The Commission has issued the enclosed Amendments Nos. 76 and 43 to Facility Operating Licenses Nos. DPR-51 and NPF-6 for Arkansas Nuclear One, Units Nos. 1 and 2 (ANO-1 & 2). These amendments consist of changes to the Technical Specifications in response to your application transmitted by letter dated November 5, 1982, supplemented by letters dated February 17, 1983, March 3, 7, 10, 21, 22, 24, 28 and 29, 1983, and April 5 and 7, 1983.

These amendments allow an increase in the storage capacity for the ANO-1 spent fuel pool from 589 to 968 storage locations and of the ANO-2 spent fuel pool from 485 to 988 storage locations.

AMENDMENT TO FACILITY OPERATING LICENSE

Amendment No. 76
License No. DPR-51

Figure 3.8.1

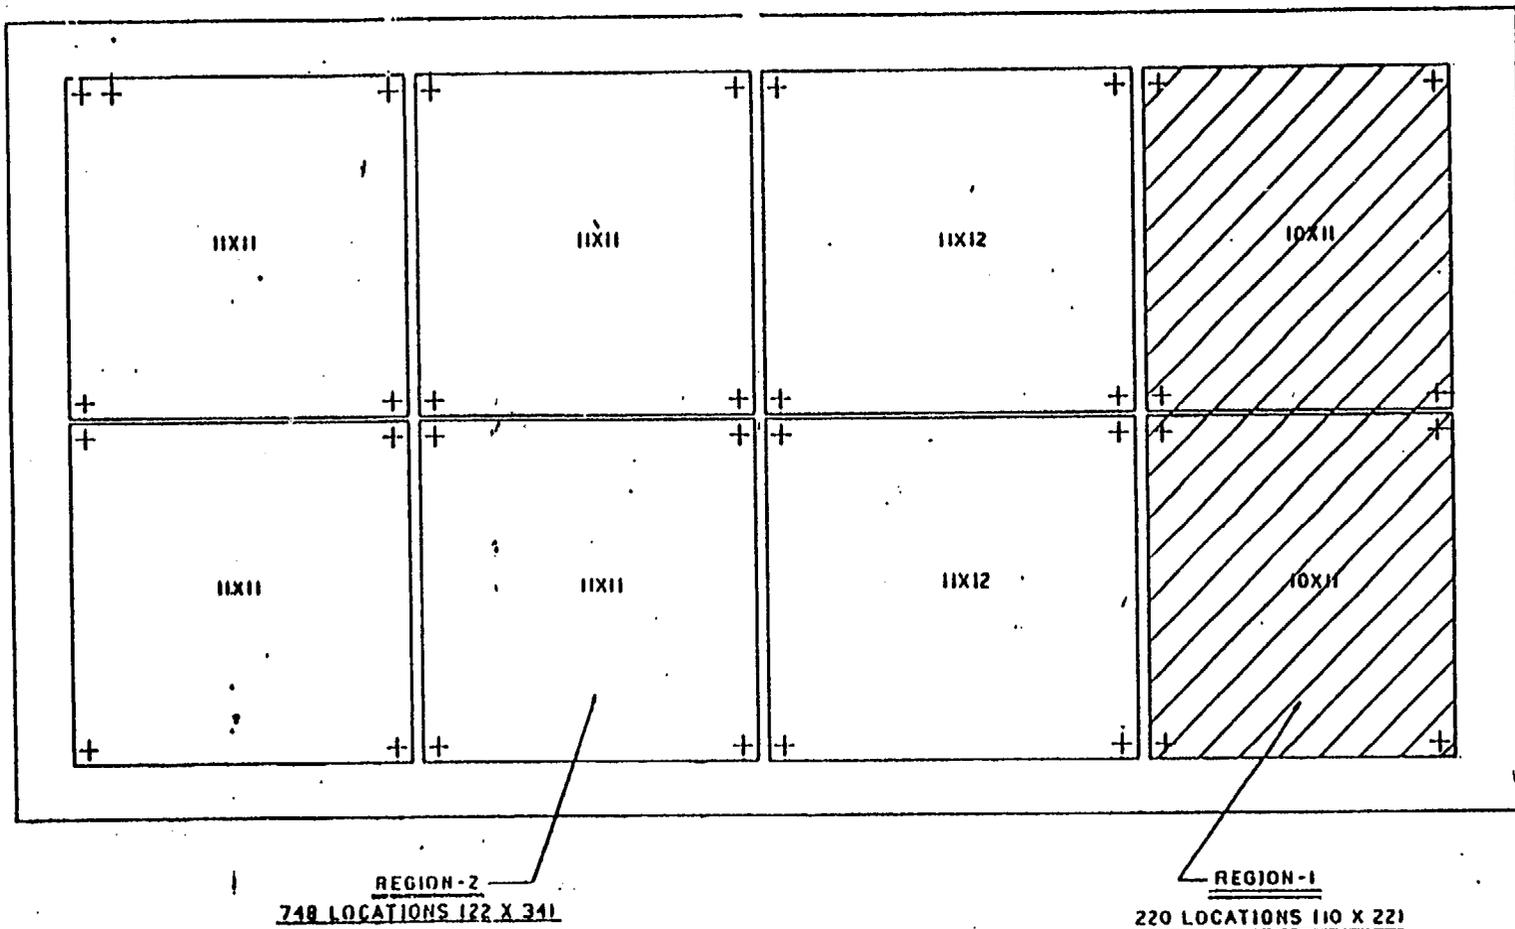
Replace the following pages of the Appendix A Technical Specifications with the enclosed pages. The revised pages are identified by Amendment Number and contain vertical lines indicating the areas of change.

FIGURE 3.8.2

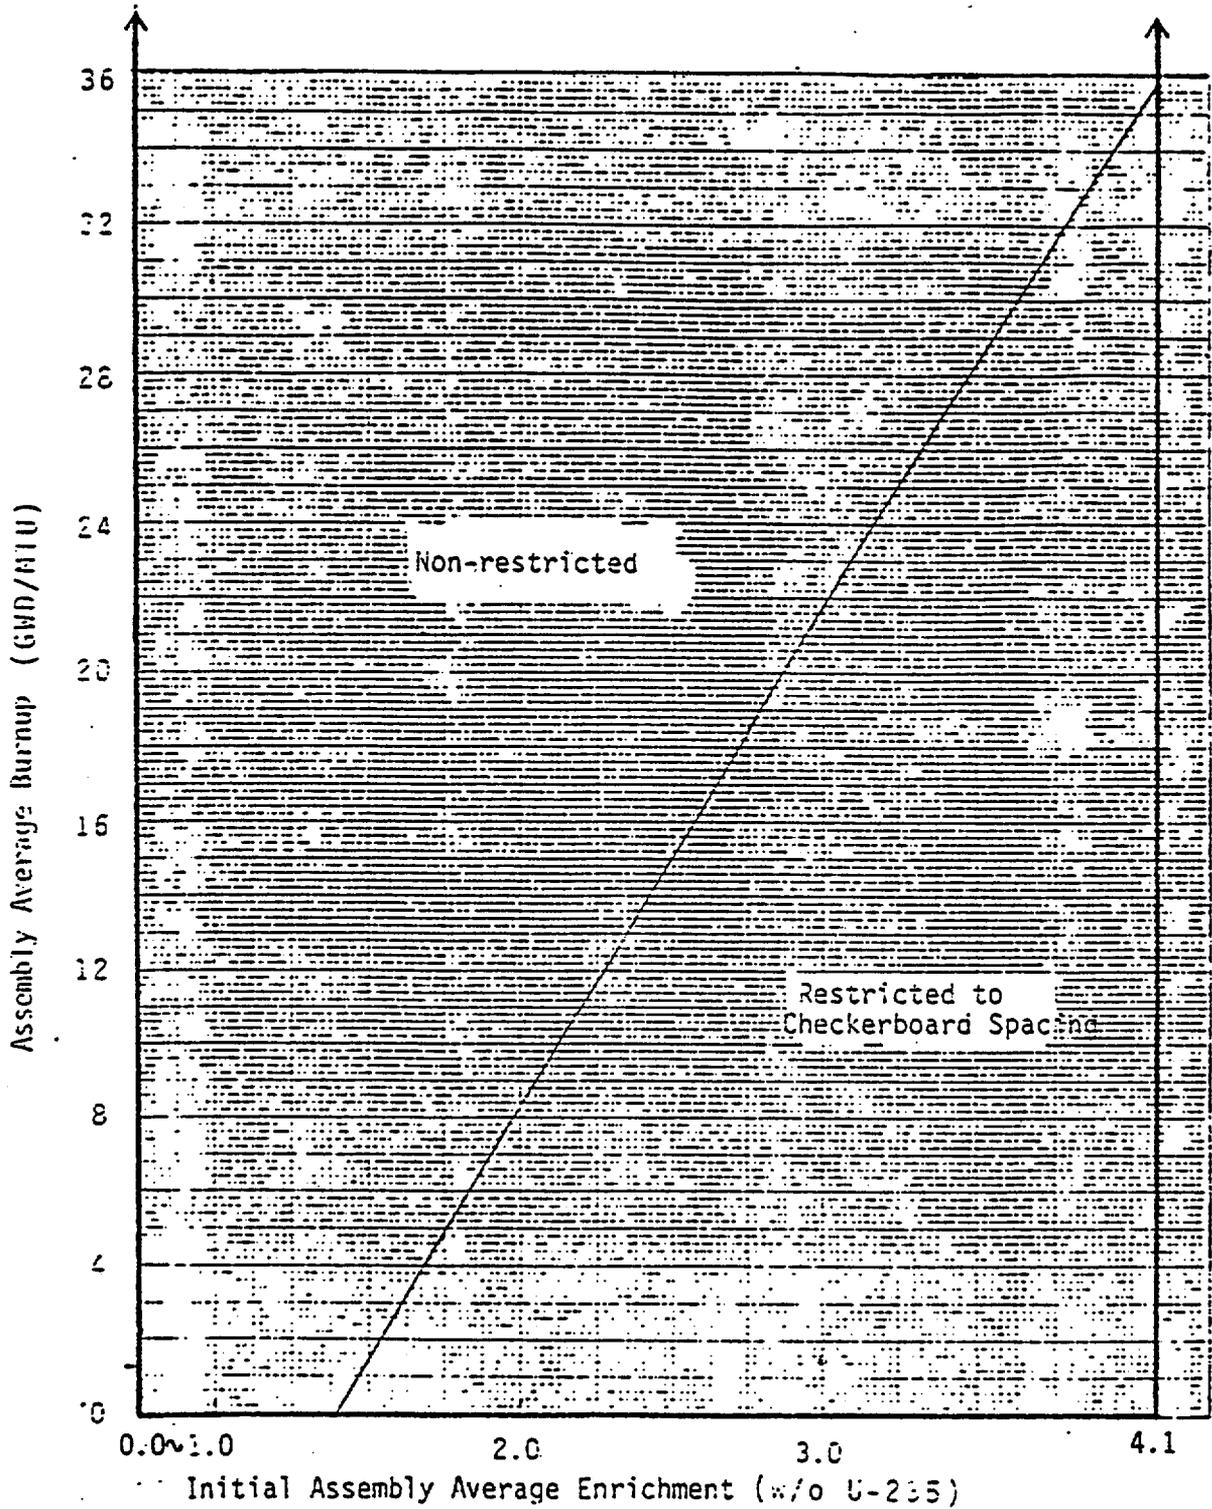
Specifications 3.8.16 and 3.8.17 assure fuel enrichment and fuel burnup limits assumed in the spent fuel safety analyses will not be exceeded.

In order to establish burnup criteria for storage in Region 2 for each unit, a constant storage rack infinite multiplication factor (with minimum post-shutdown fission product inventory) contour is constructed as a function of burnup and initial enrichment using LEOPARD and TURTLE. This contour is based on a high enrichment endpoint of 4.10 weight percent and 36,000 MWD/MTU as shown in Figure 3.8.2 from the proposed ANO-1 TSS and in Figure 3.9.2 from the proposed ANO-2 TSS.

The final multiplication factors for Region 2 are determined using the same KENO IV method used for Region 1 with the conditions determined by the zero burnup intercept point in Figure 3.8.2 for ANO-1 and Figure 3.9.2 for ANO-2. In these cases, the intercept points are at 1.4 weight percent U-235. Therefore, the design mode for Region 2 for ANO-1 & 2 is an unirradiated assembly of 1.4 weight percent initial enrichment. LEOPARD and TURTLE are thus used only to calculate relative reactivities as a function of burnup while the KENO IV Monte Carlo method is used to determine the actual storage rack reactivity. The nominal case multiplication factors are calculated to be 0.8892 for ANO-1 and 0.9068 for ANO-2. Increasing these by the above calculated 95/95 uncertainty of 2.48 percent gives final Region 2 multiplication factors of 0.914 for ANO-1 and 0.9316 for ANO-2 which meet our acceptance criterion of less than or equal to 0.95. Based on our review, we conclude that any number of B&W design 15X15 fuel assemblies with burnups in the non-restricted region of Figure 3.8.2 may be stored in Region 2 of the ANO-1 spent fuel storage racks and that any number of CE design 16X16 fuel assemblies with burnups in the non-restricted region of Figure 3.9.2 may be stored in Region 2 of the ANO-2 spent fuel storage racks.

Figure 3.9.1

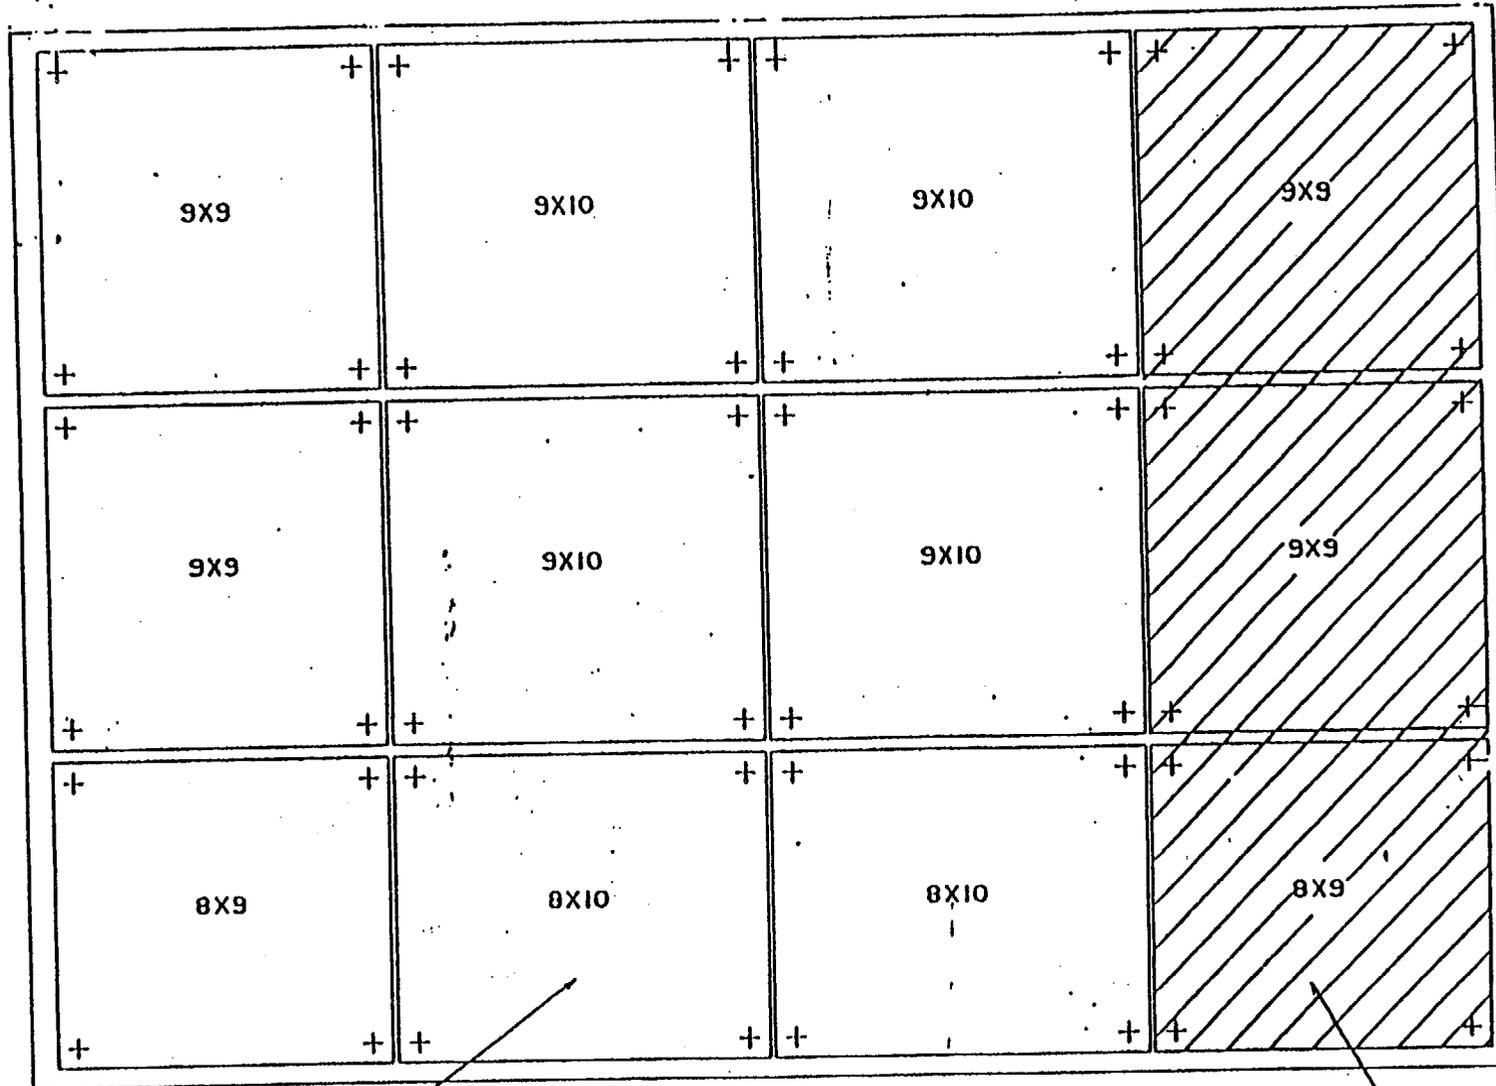
Replace the following pages of the Appendix A Technical Specifications with the enclosed pages. The revised pages are identified by amendment number and contain vertical lines indicating the areas of change. Corresponding overleaf pages are provided to maintain document completeness.

REGION-2
754 LOCATIONS (26 X 29)

REGION-1
234 LOCATIONS (9 X 26)
